Objection number**OBJ09**
Objector's Name Stephen O'Kane
Date submitted..... 05 March 2015
NIMVO plot number N/A

TransportNI has considered the correspondence in the above objection and responds as follows:

Client TRANSPORT NI	Project Title YORK STREET INTERCHANGE	Drawing Title YORK STREET INTERCHANGE PLAN REVISED NMU PROVISION PRE-INQUIRY	Designed EB	Drawn EB	Checked JM	Approved JM	Date 02/10/15	URS Infrastructure & Environment Ltd (EMI) Beech Hill House 40 Beech Hill Road Belfast Tel: +44 2890 705 111 Fax: +44 2890 705 651 www.ursgroup.com
			URS Internal Project No. 47037827		Sustainability Fit for Information		URS	
			Scale @ A1 1:1250		Zone / Mileage Non-Motorised Users		Drawing Number TNI_YSI-JURS-ENM-ZZ-DR-HY-000007	
			THIS DOCUMENT HAS BEEN PREPARED PURSUANT TO AND SUBJECT TO THE TERMS OF URS' APPOINTMENT BY ITS CLIENT. URS ACCEPTS NO LIABILITY FOR ANY USE OF THIS DOCUMENT OTHER THAN BY ITS ORIGINAL CLIENT OR FOLLOWING URS' EXPRESS AGREEMENT TO SUCH USE, AND ONLY FOR THE PURPOSES FOR WHICH IT WAS PREPARED AND PROVIDED.				Rev P02

**YORK STREET INTERCHANGE
TYPICAL SECTION
REVISED NMU PROVISION
PRE-INQUIRY**

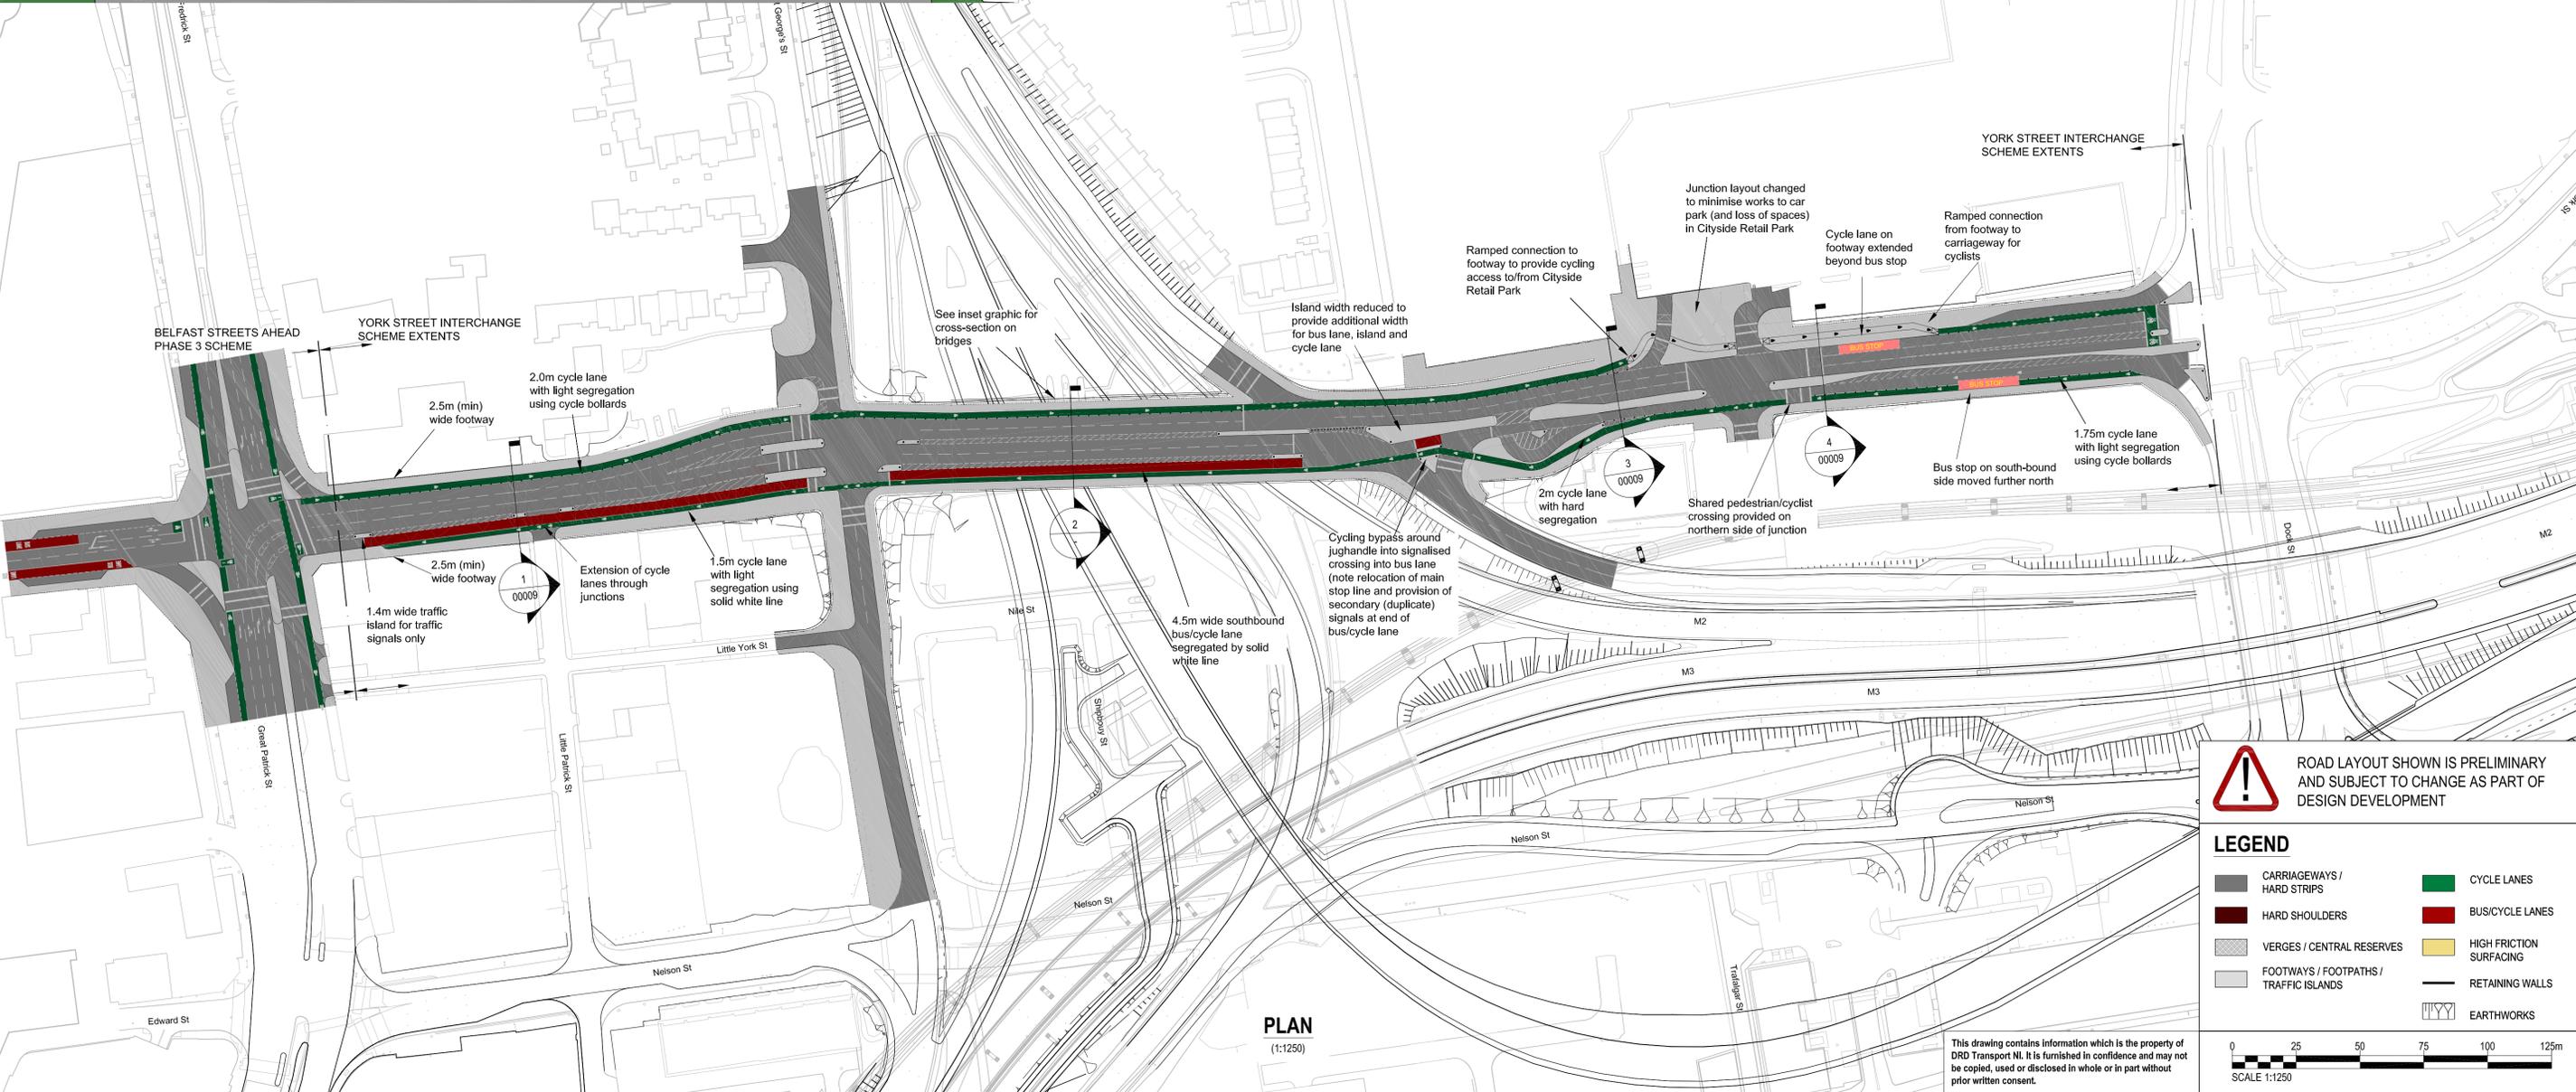
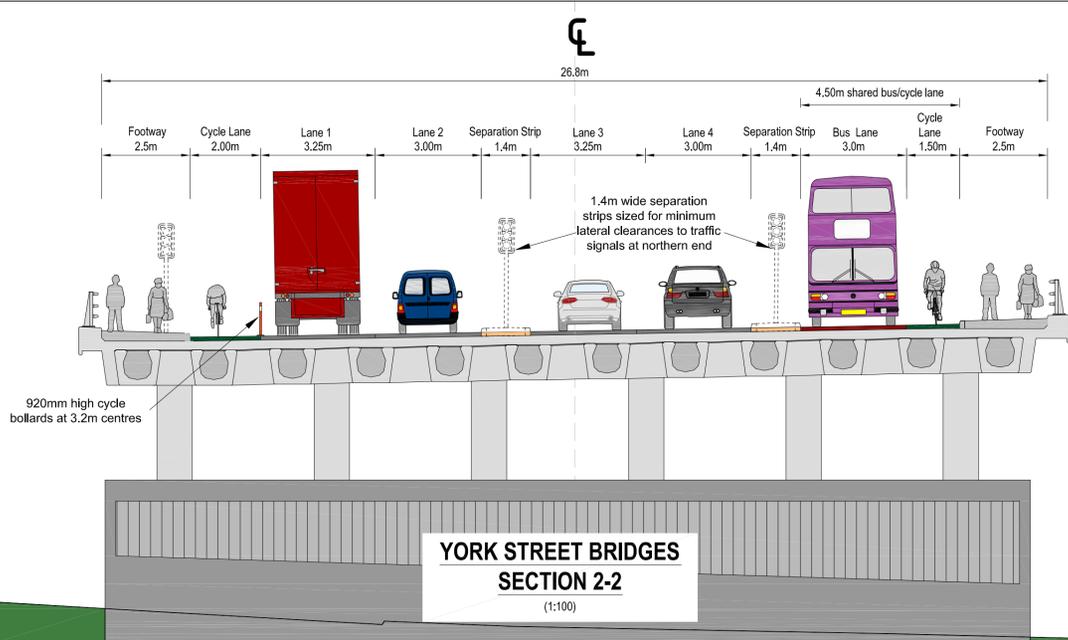
To allow only 1.5m for cyclists in an unprotected lane out of over 27metres in total width is unfathomable. This single statistic shows clearly how much consideration was given to cyclists in this design.

7. Another flawed aspect is the junction design. There has been as much consideration for cyclist in the junction design as there has been in the width allocation for cyclists.

- **The York Street/Frederick St junction southbound should provide provision for a cyclist turning right into Frederick St for the University parking facility.**

- **No cycle lanes have been provided at all on York Street between Frederick St and Gt Georges St.**
- **No provision for southbound cyclists to turn right onto Gt Georges St.**

- **Southbound bus/cycle lane narrows to a dangerous pinch point at Gt Georges St/York St junction.**
- **Southbound buses on York Street bridge/overpass will either have to squeeze past cyclists or move into oncoming traffic, either situation is highly dangerous.**

- **The cycling lane markings should continue through the junctions * especially on the southbound direction reaching the York St bridge/overpass otherwise M2 traffic will likely cut across cyclists.**

- **pinch points at the traffic signals must be resolved. Pinch points such as this cause the most difficulty for cyclists forced to share road space with incompatible vehicular traffic.**

a) Following the statutory consultation period, TransportNI has further engaged with Sustrans and DRD Cycling Unit to review provision for all non-motorised users on York Street. All aspects raised by your response have been considered in developing a revised proposal.

b) We enclose two drawings illustrating the revised proposal for your information. The revised proposal will be available for discussion at the upcoming Public Inquiry.

- a) Following the statutory consultation period, TransportNI has further engaged with Sustrans and DRD Cycling Unit to review provision for all non-motorised users on York Street. All aspects raised by your response have been considered in developing a revised proposal.
- b) We enclose two drawings illustrating the revised proposal for your information. The revised proposal will be available for discussion at the upcoming Public Inquiry.

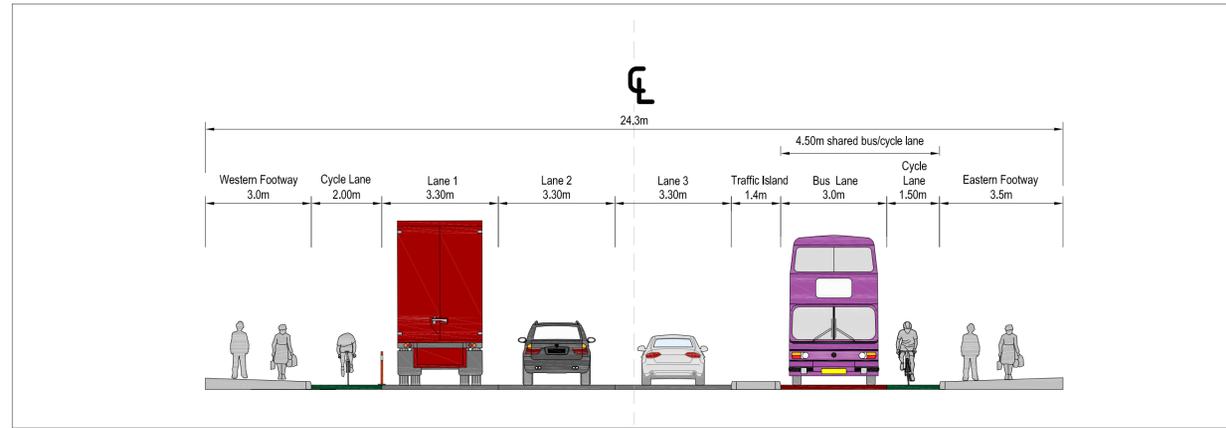
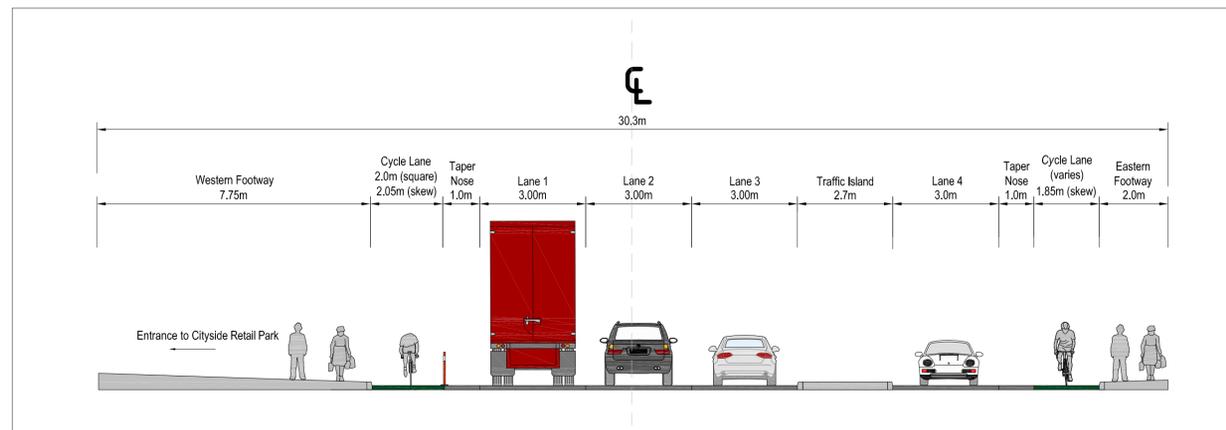
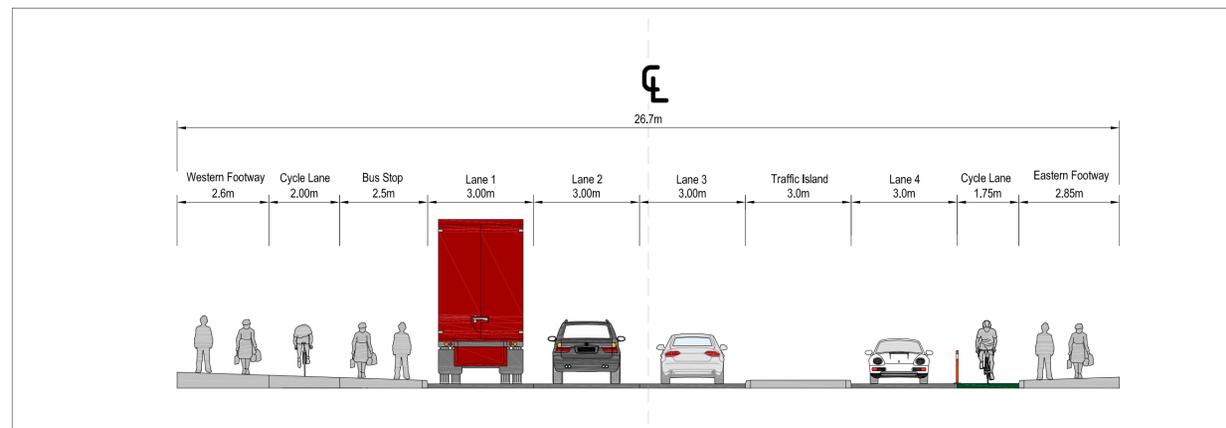
There is enough width in this bridge/overpass to allow wide footpaths, segregated bus lanes, protected cycle lanes and enough lanes for other motorised traffic.
